# Groundwater Transfer Review Summary Form

Transfer/PA # T- 14220

Application: T-14220

Applicant Name: Four H Organics LLC

**Malin Area Hydrographs****KLAM 14829 Hydrograph**

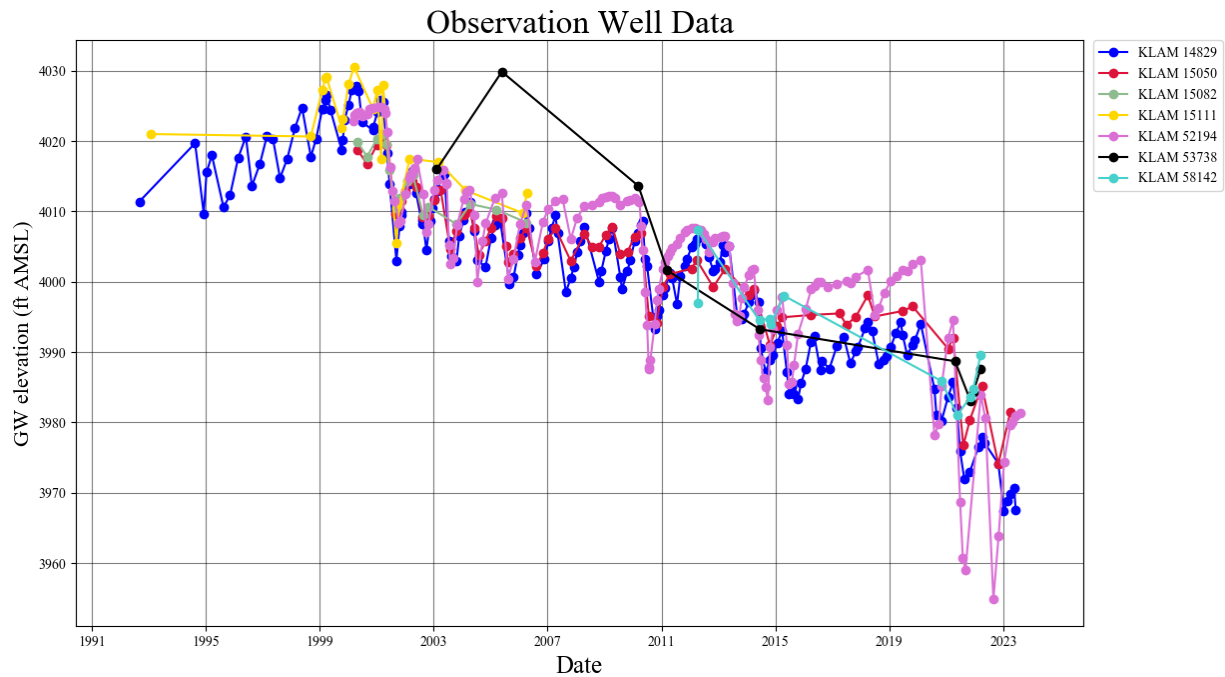
7. What conditions or other changes in the application are necessary to address any potential issues identified above: \_\_\_\_\_
8. Any additional comments: Groundwater level data from wells in the Malin area of the Tule Lake Valley indicate significant declines have occurred since 2001 (See attached area well hydrograph). **KLAM 14829** is located a little over a quarter of a mile to the west of the from well **KLAM 15111** and has seen 57.09 feet of decline from an annual high of 215.58 feet below land surface (bls) in April 12, 2000 to 272.67 feet bls in May 17, 2023 (See attached hydrograph of KLAM 14829). When looking at the combined hydrographs of the "Haught" well and the "Strum" well, a similar declining trend is apparent (See attached POA hydrograph).

While recent groundwater data is not available from From-POA **KLAM 15111**, it is likely that the 25 foot of decline condition has been triggered. This statement is supported by the 57.09 feet of total decline observed in **KLAM 14829** (with over 23.27 feet of decline occurring since 2020) and the general decline trends observed in wells that source water from the volcanics at depth in the Malin area.
